PLANNING COMMISSION MEETING STAFF REPORT

NAME OF PROJECT: Ameyalli Resort Development

AGENDA ITEM: Ameyalli Resort Phase 1 Preliminary

Subject: Ameyalli – Phase 1 Preliminary Review

PROPOSED ROADS, PARKING AND TRAILS PLAN I

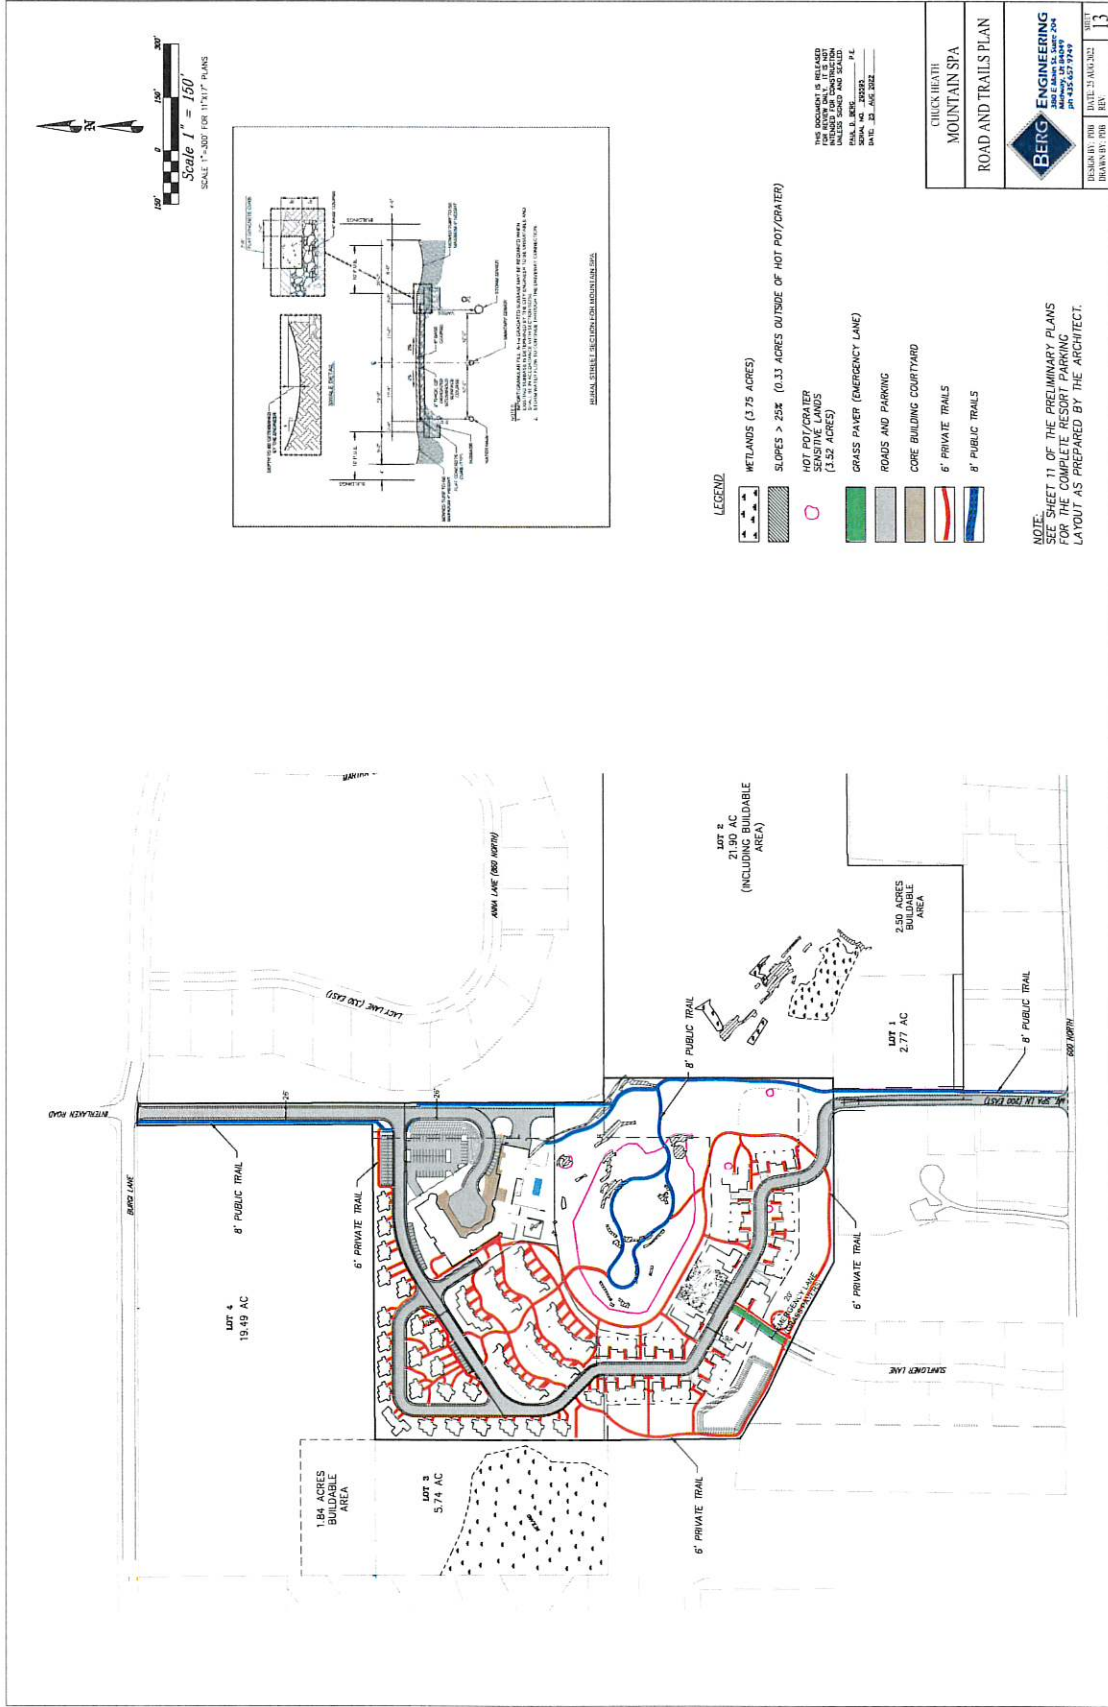
Private Trails – There are many 6’ private trails in the development. These trails will be used by the guests to travel from lodging areas to amenity area. The plan does not specify the surface material for the trails but either a concrete or paved surface should be required and will be more feasible in the varied climate of Midway.

- Roads within the proposed Phase 1 will connect to both Burgi Lane and 200 East at 600 North, with a third emergency access connecting to Sunflower Lane. Each road will be built to Rural City Street standard. The proposed cross-section is 22' of asphalt with two 2' concrete ribbon curbs, for a total width of 26'
- The roads within the resort will be private roads with a public easement.
- Each of the improvements within 200 East, road, water, irrigation, and any private improvements will be installed and paid for by the Ameyalli Resort.
- The existing power line along 200 East should be buried as part of the Ameyalli Phase 1 improvements.
- A traffic study has been submitted and reviewed and accepted.

- An 8' paved public trail running north to south from Burgi Lane through the development and connecting to 600 North is shown on the proposed plans. This trail will provide connectivity from existing trails on Burgi Lane, and 600 North to the Valais Park. The trail will be a valuable link to the Midway City trails system. The trail is shown to be completed as part of Phase 1.

PROPOSED OVERALL UTILITIES PLAN I

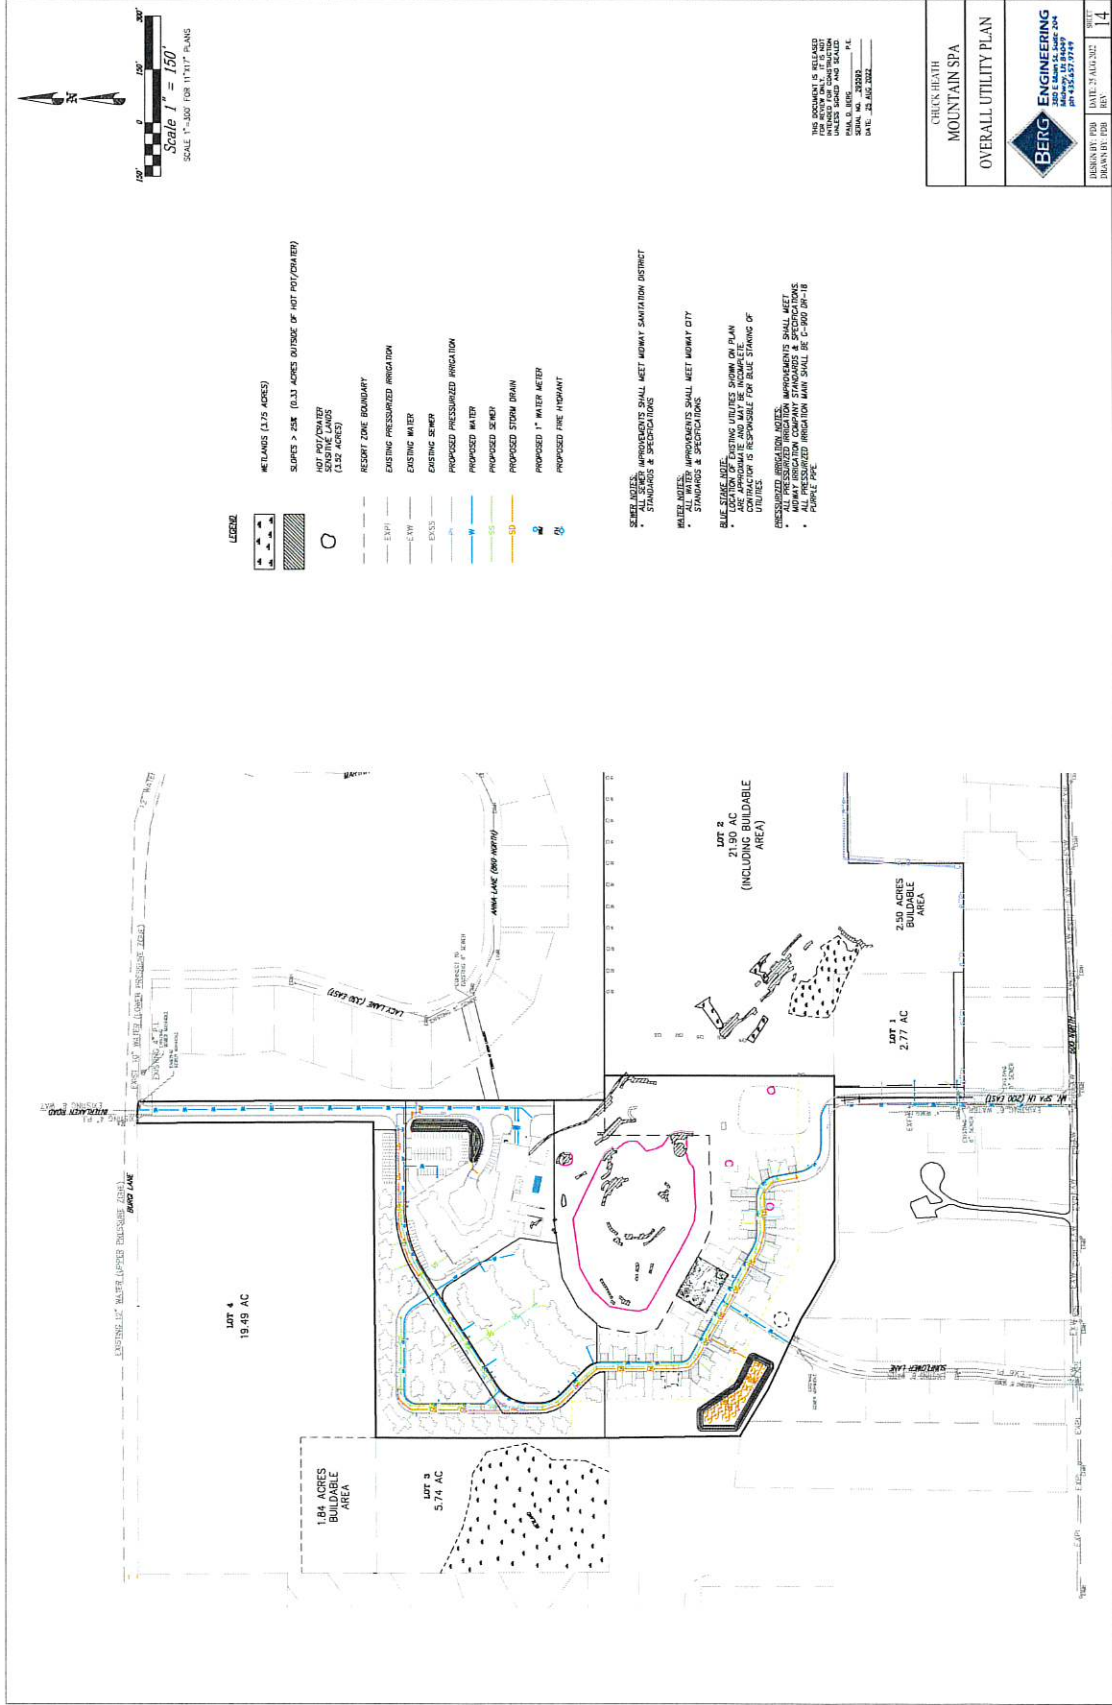
- Phase 1 will be served from the Gerber / Mahogany pressure zone.
- To provide the adequate fire flow, the proposed 8" water line will connect to the existing 10" Gerber zone water line within Burgi Lane, the existing 10" water line in Sunflower Lane, and the proposed upsized 8" water line in 200 East.
- The proposed 8" water lines within the development will provide fire flows of approximately 2,000 gpm. To provide these fire flows all water lines should be installed with phase one.

PROPOSED PRESSURIZED IRRIGATION PLAN I

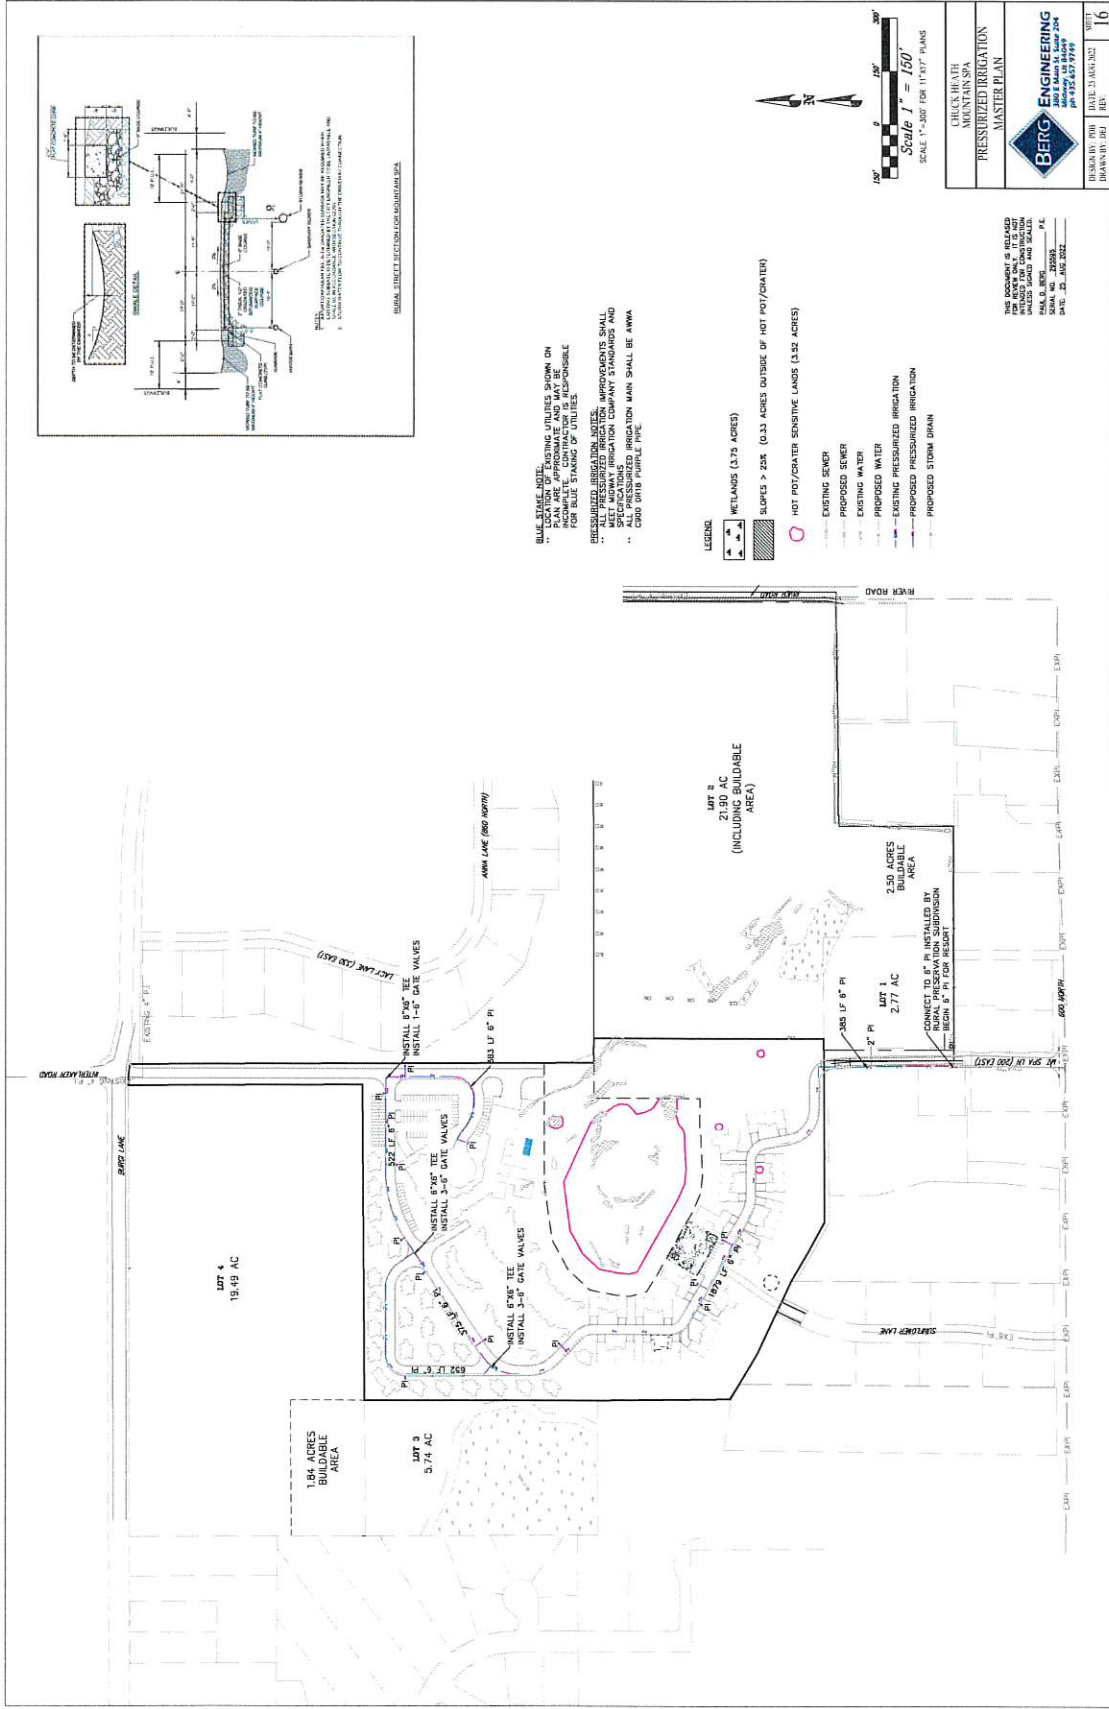
- The resort will be serviced by Midway Irrigation. To date a design for the booster pump has not been provided to the developer.

- Prior to Phase 1 receiving Final approval the design for the irrigation pumping system should be submitted to and accepted by the Developer. This should be both the pump design and the pump and pipeline location.

PROPOSED STORM DRAIN MASTER PLAN I

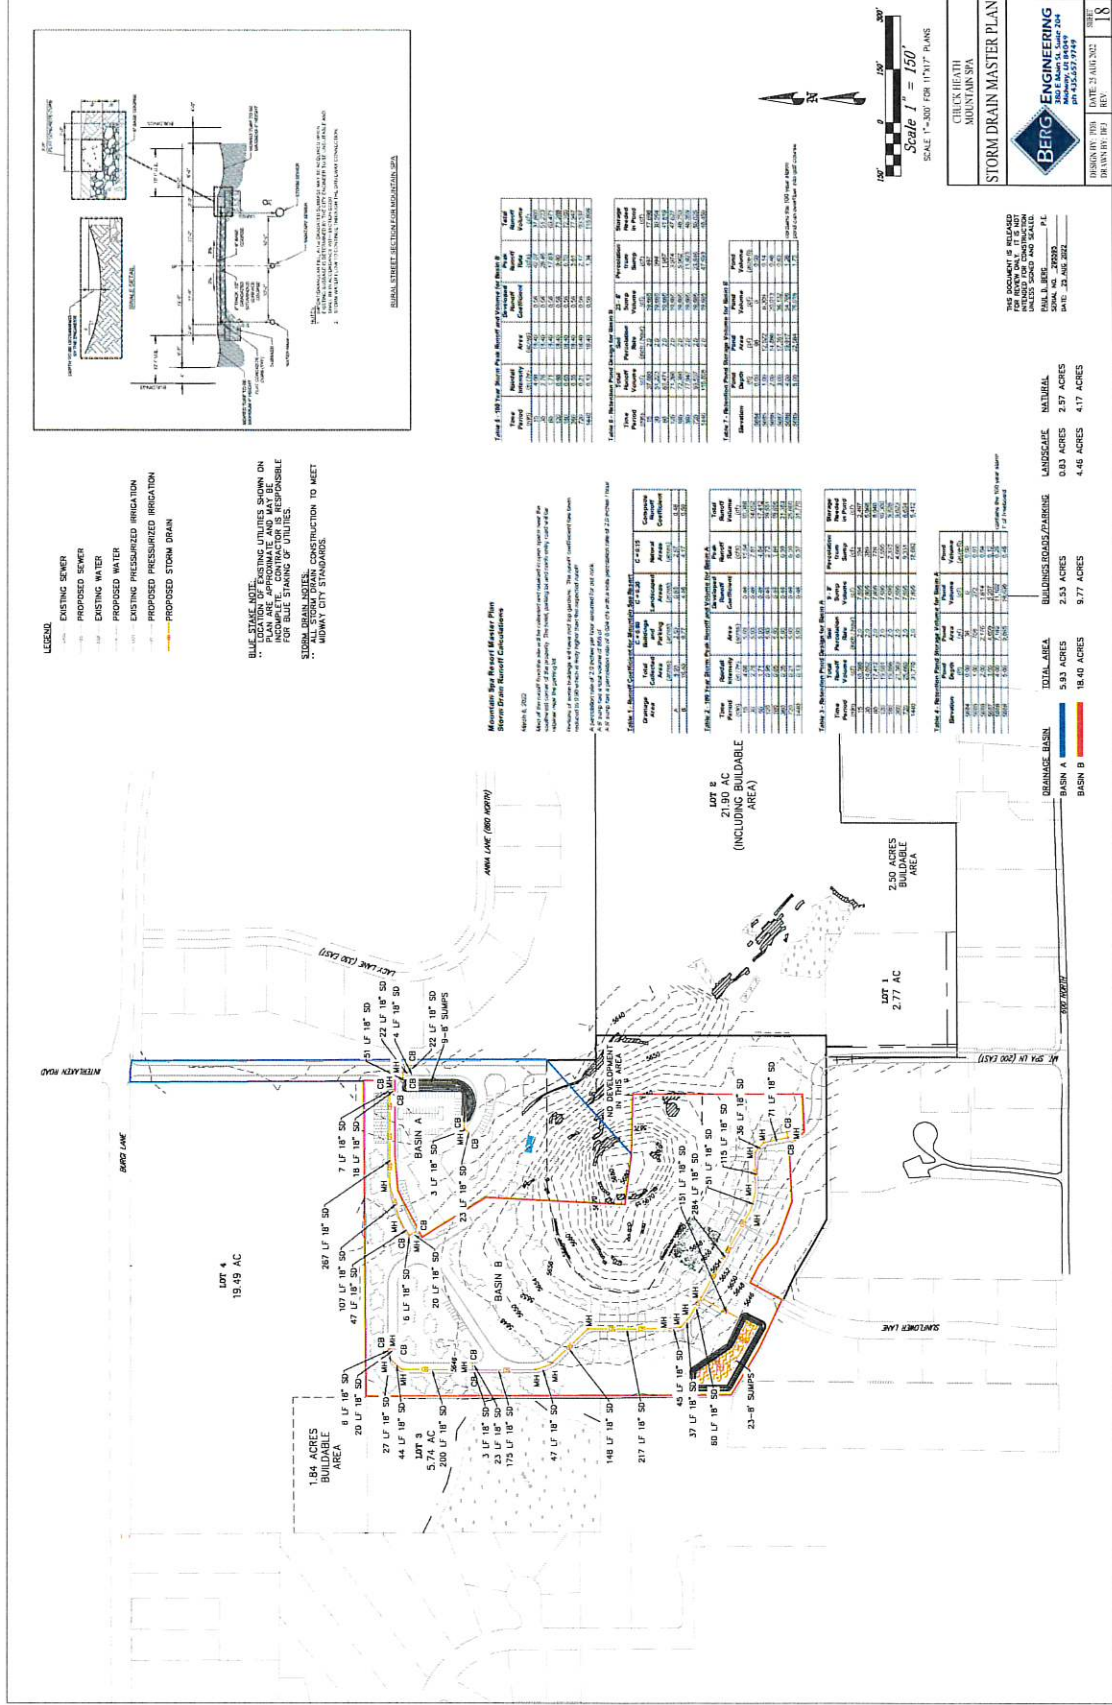
- The storm drain system will be a private. The system will collect and retain all storm water onsite through catch basins and retention basins. The storm drain system will be a private system maintained by the owner.
